MACARTHUR BOULEVARD BIKEWAY SEGMENT 3 MANDATORY REFERRAL NO. 2022012

No. MR2022012

MANDATORY REFERRAL – 35 PERCENT DESIGN PLANS

Staff recommends approval of the MacArthur Boulevard Bikeway Segment 3 project 35 percent design plans (MR2022012) with the following comments.

Figure 11 – Looking Northbound – Crosswalk of MacArthur Boulevard at Sangamore Road/Madaket Road

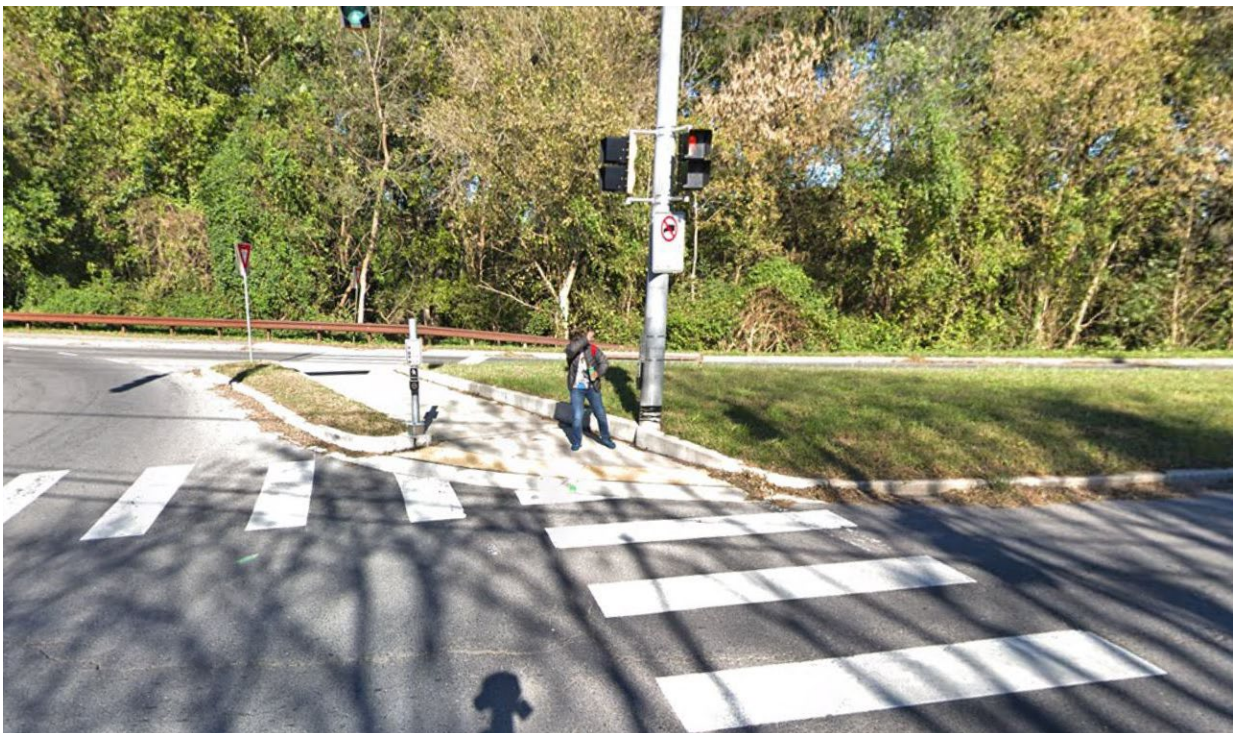
6. MacArthur Boulevard/Sangamore Road/Madaket Road intersection

Provide a high-visibility crosswalk on the eastbound leg of MacArthur Boulevard at Sangamore Road/Madaket Road. Also, provide separate accessible ramps on the southeast corner for the crosswalks crossing MacArthur Boulevard and Madaket Road. Pedestrian corner refuge area improvements are also needed on the southeast corner to accommodate current and future use, as this intersection will provide a major connection for bicyclists and pedestrians between the MacArthur Boulevard sidepath, the future American Legion bridge connection, and the Little Falls Stream Valley and Capital Crescent Trails. There is also concern about the multi-stage crossing required for bicyclists and pedestrians to cross on the westbound leg, so intersection modifications should be explored by the Montgomery County Department of Transportation in the future at this intersection.

1. The current design of the MacArthur Boulevard/Sangamore Road/Madaket Road intersection has some vision zero concerns. The movement from northbound MacArthur Boulevard to Sangamore Road is essentially a slight right using a channelized turn bay. This is a practice that the County is trying to minimize to the extent possible. Because of this geometry bicyclists and pedestrians trying to cross MacArthur Boulevard from the Capital Crescent Trail and from the east side of Sangamore Road, must cross two crosswalks, first the right turn slip lane which is yield controlled (see Figure 9), and the second at a signalized crosswalk on MacArthur

Boulevard at Sangamore Road (see Figures 10 and 11). The corner on the south side of MacArthur Boulevard has limited pedestrian/bicycle refuge space at the intersection corner, and this is a safety concern.

MR-01
TRAIL LAYOUT CONCEPT
MACARTHUR BOULEVARD
BIKEWAY PHASE III

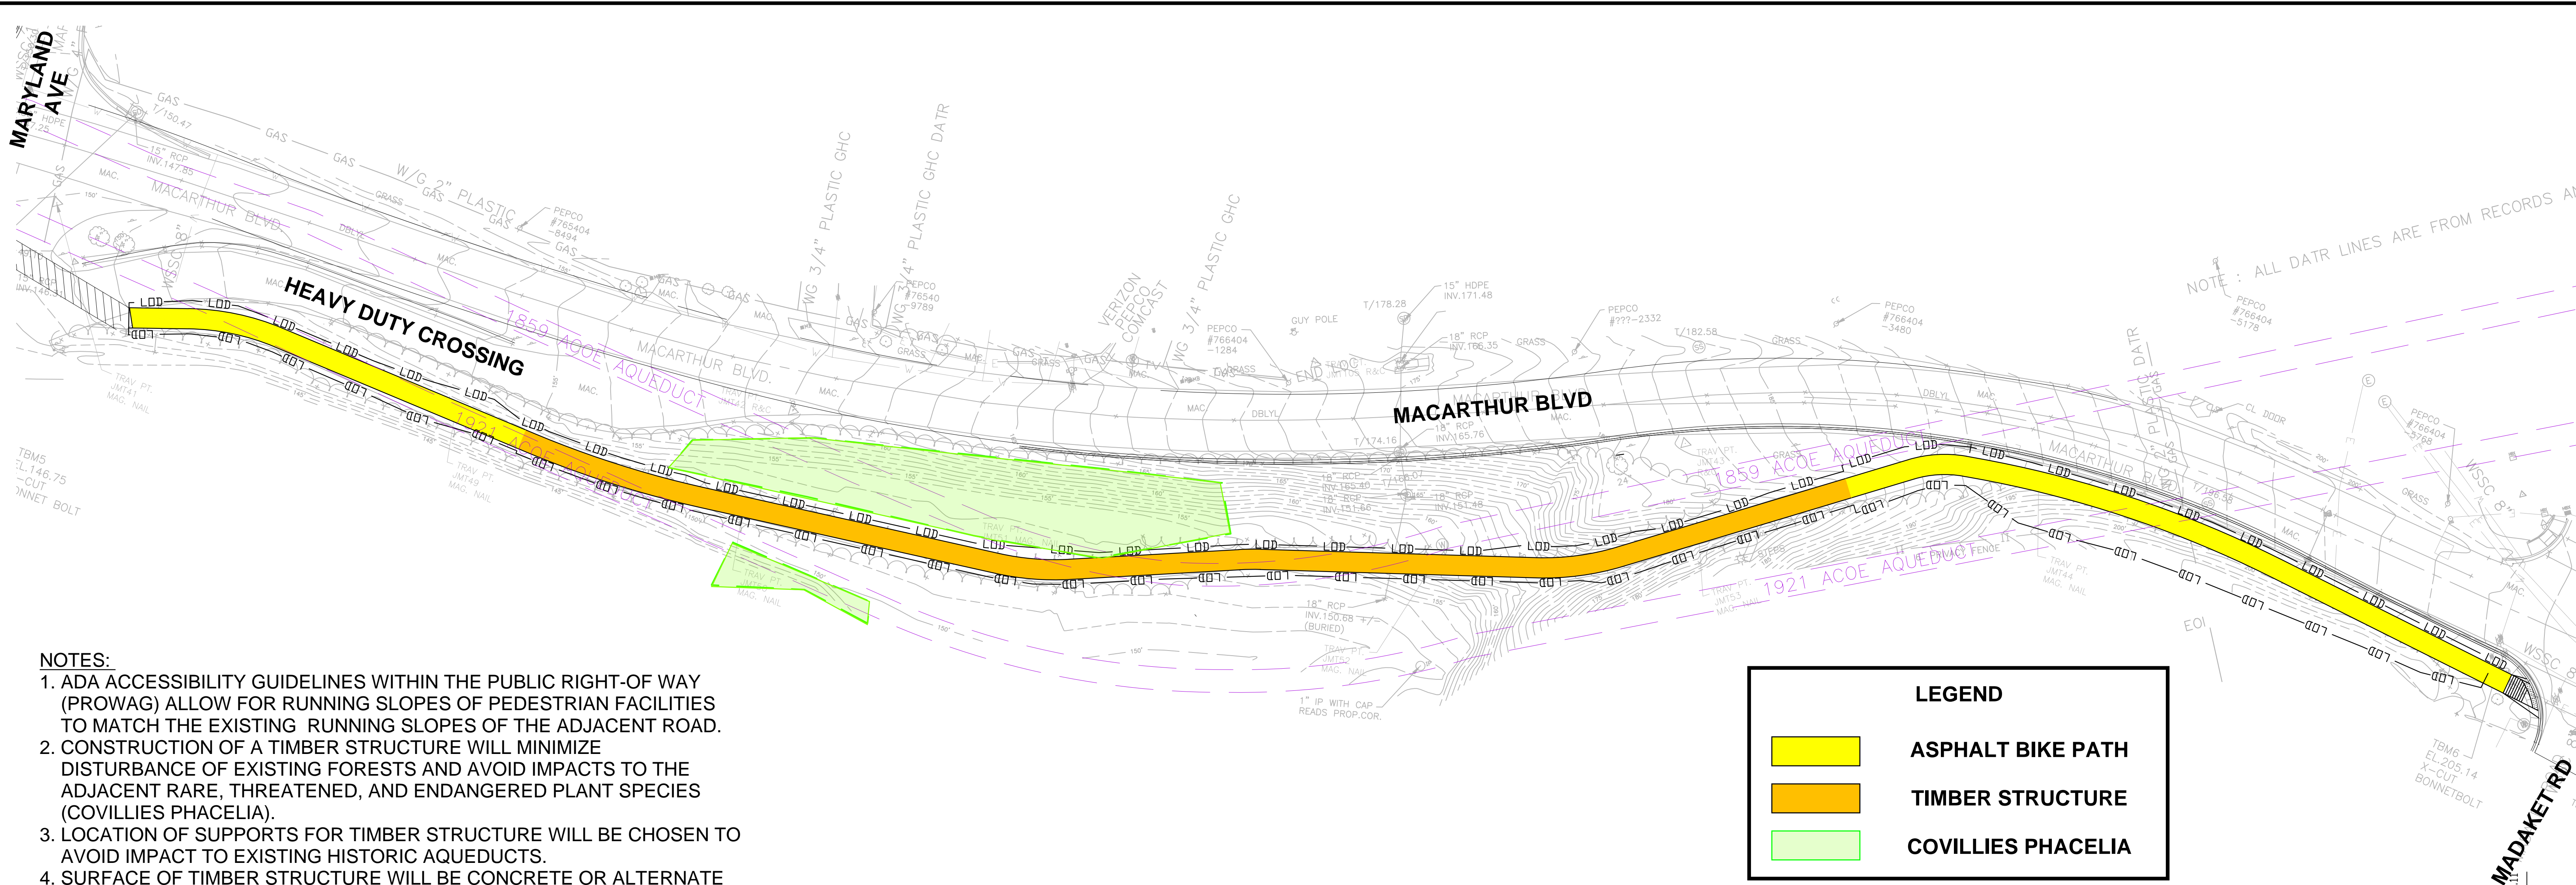
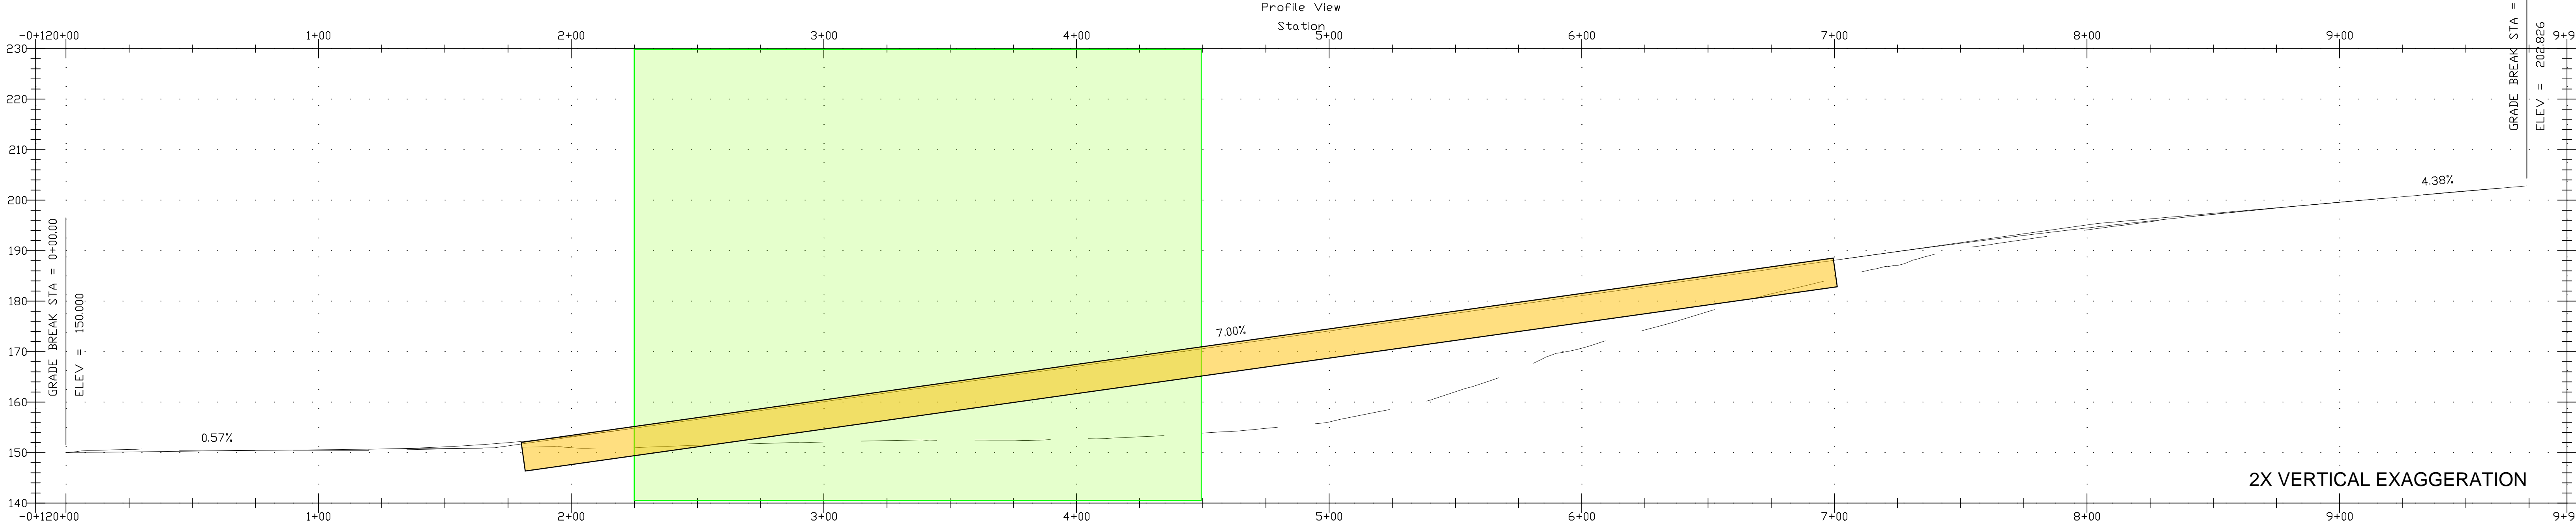
DESIGN ISSUE – STEEP GRADE SIDEPATH SECTION WEST OF SANGAMORE ROAD

There is a short section of the sidepath to the west of Sangamore Road where the existing grade is close to 20 percent. The project included the development of alternative concepts to provide conformance with the Americans with Disabilities (ADA) act to reduce this steep slope. Options considered and rejected (largely due to opposition from the US Army Corps of Engineers) included a switchback ramp layout and an elevated wooden boardwalk structure. The current concept, shown in Attachment C, was developed to redesign the sidepath to limit the grade to 12 percent. While not in compliance with ADA, it represents a significant improvement.

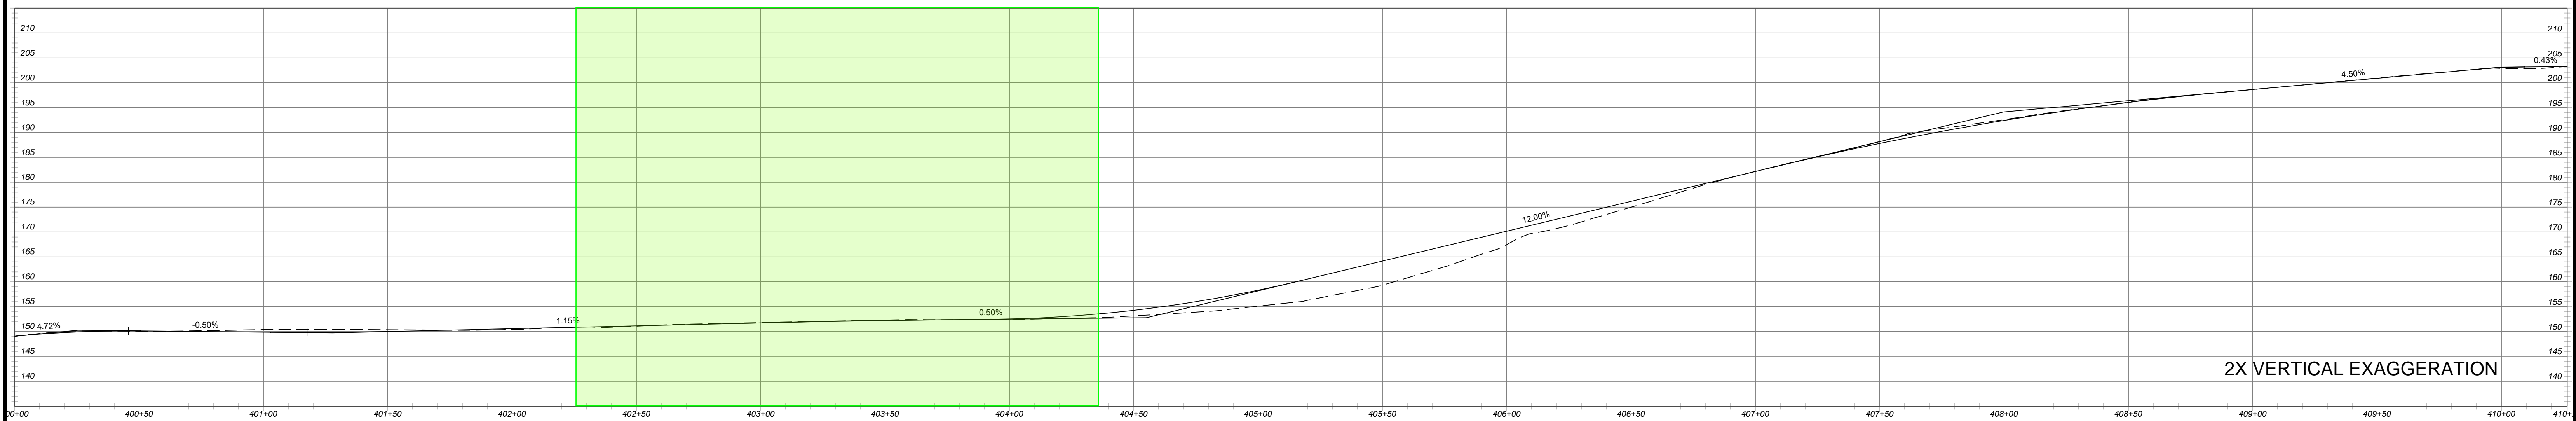
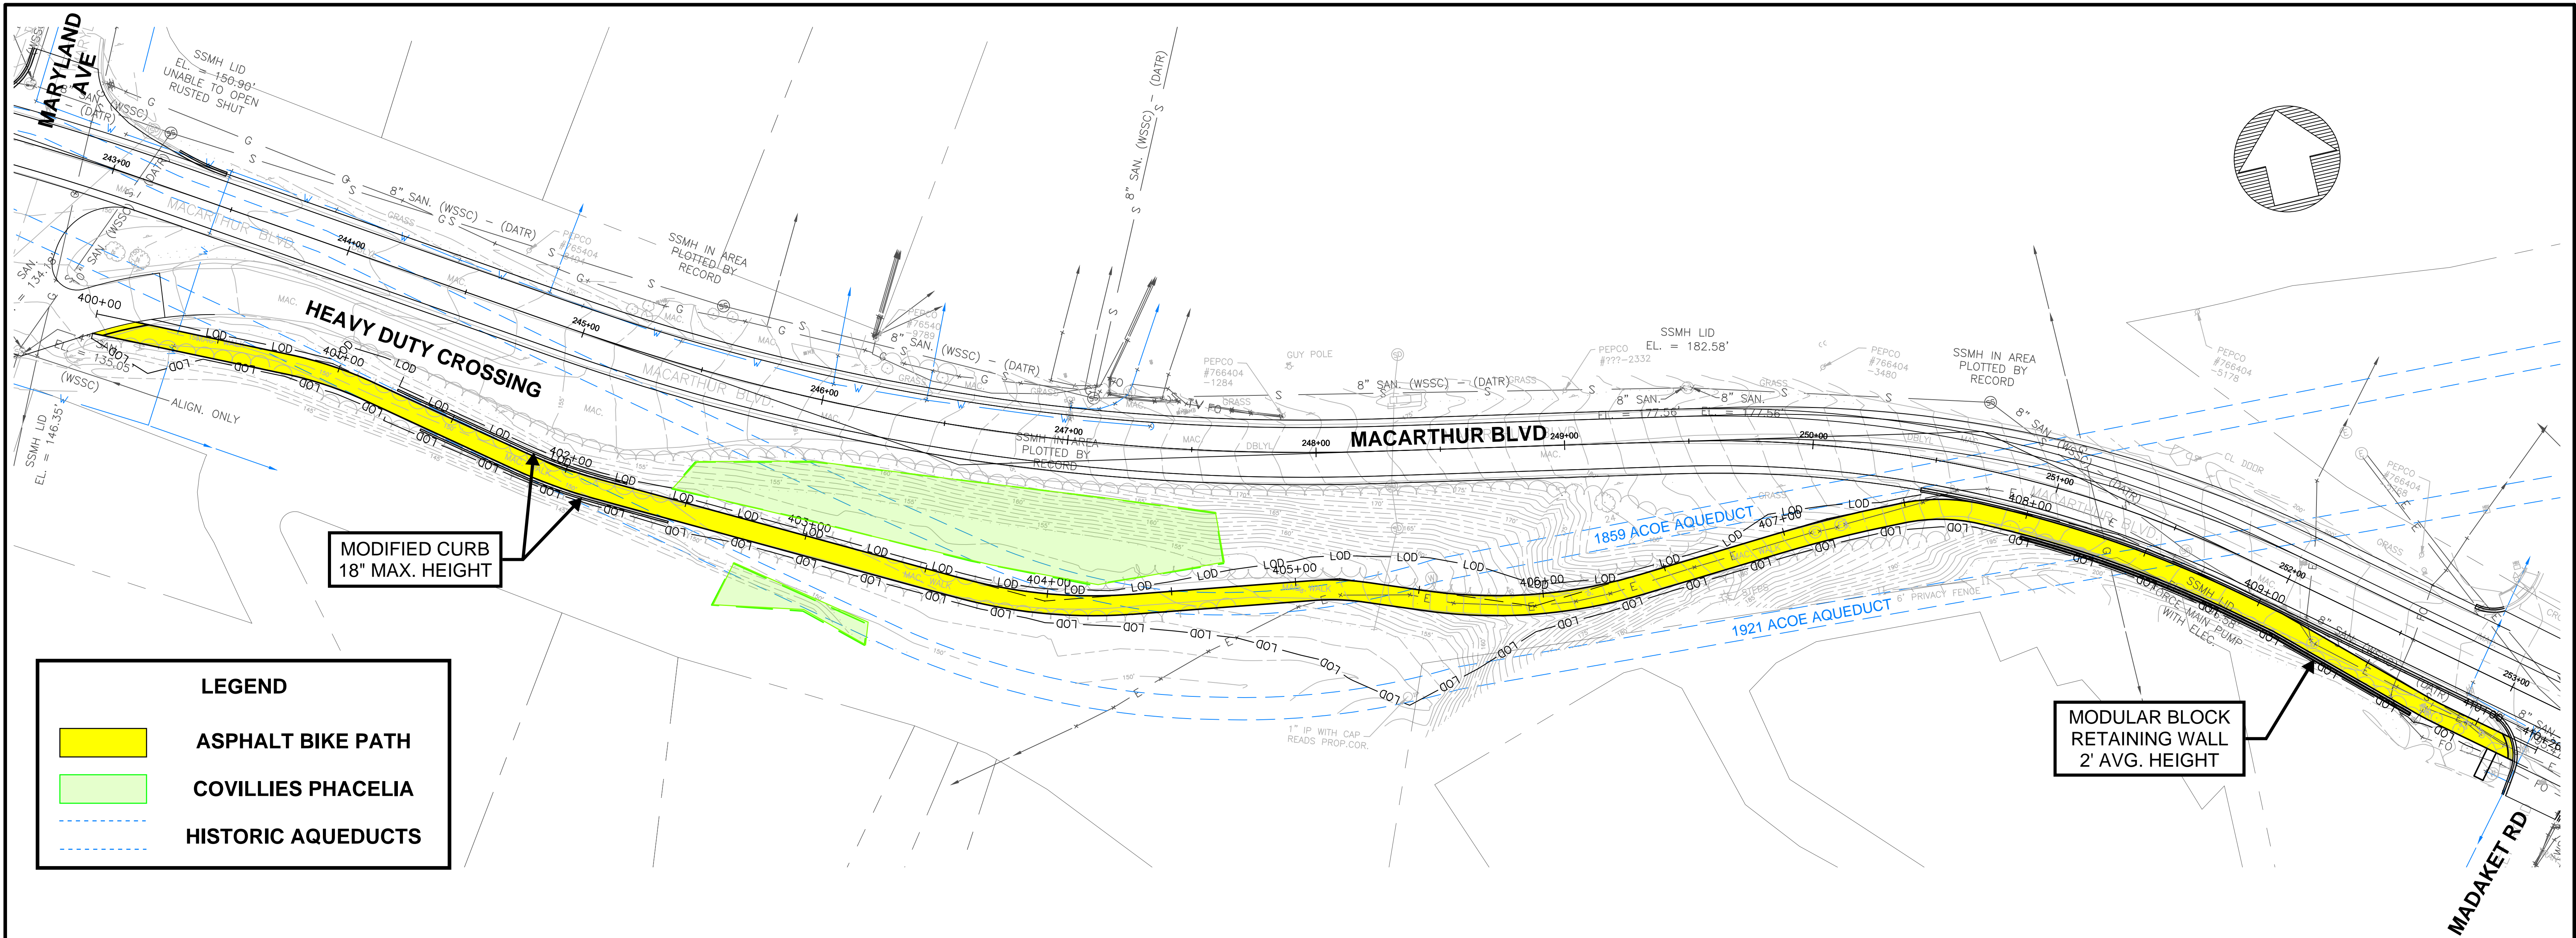
- NOTES:**
- COORDINATION WITH U.S. ARMY CORPS OF ENGINEERS HAS RESULTED IN A REQUEST THAT NO STRUCTURAL FOUNDATIONS BE CONSTRUCTED IN CLOSE PROXIMITY TO EXISTING HISTORIC AQUEDUCT STRUCTURES.
 - PROPOSED DESIGN WILL NEED TO BE REVIEWED AND APPROVED BY U.S. ARMY CORPS OF ENGINEERS PRIOR TO FINAL DESIGN.
 - PROPOSED DESIGN SEEKS TO MINIMIZE PROPOSED DISTURBANCE OF EXISTING FORESTS AND AVOID IMPACTS TO THE ADJACENT RARE, THREATENED, AND ENDANGERED PLANT SPECIES (COVILLIES PHACELIA).
 - EXISTING RUNNING SLOPE OF TRAIL IS APPROXIMATELY 18-20%.
 - PROPOSED RUNNING SLOPE OF TRAIL IS REDUCED TO A MAXIMUM OF 12%.
